Subject: Response to NRC Request for Information Concerning Low
Pressure Turbine Blade Failures and Disc Inspections

Attachment 1
Responses to NRC Questions and Discussion
of
Turbine Blade Failures

Attachment 2
Before and After
Vibration Characteristic Diagrams
Low Pressure Turbine - Fifth Stage

FIGURE 1

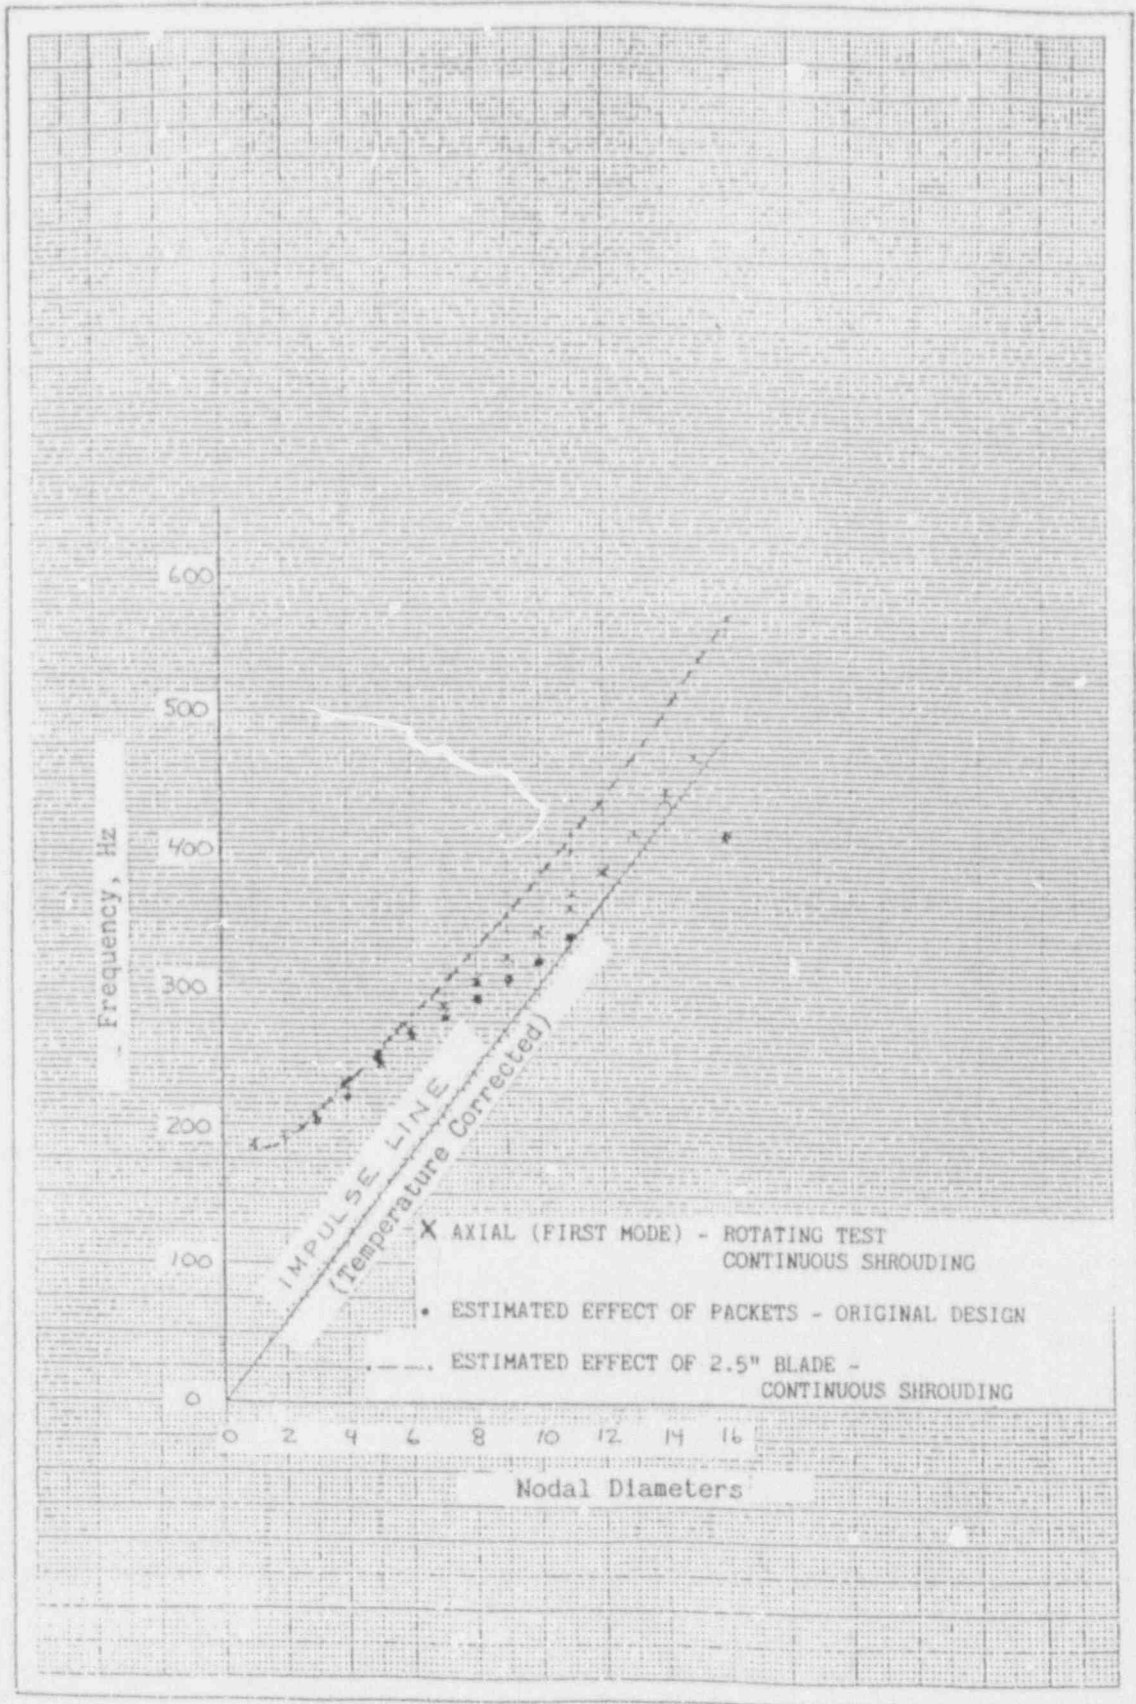
Provide before and after vibration characteristic diagrams for the LP turbine fifth stage blades.

The turbine vendor supplied before and after vibration characteristic diagrams for the LP turbine fifth stage blades are provided in Attachment 2 of this letter. Figure 1 shows the frequency response results of stationary vibration tests on the Number 2 LP Turbine fifth stage as originally installed. Figure 2 shows the predicted frequency response for various blade designs and shroud configurations. Figure 3 shows the frequency response results of stationary vibration tests on the Number 2 and Number 3 LP Turbines after the modifications were completed during the second refueling outage in 1991.
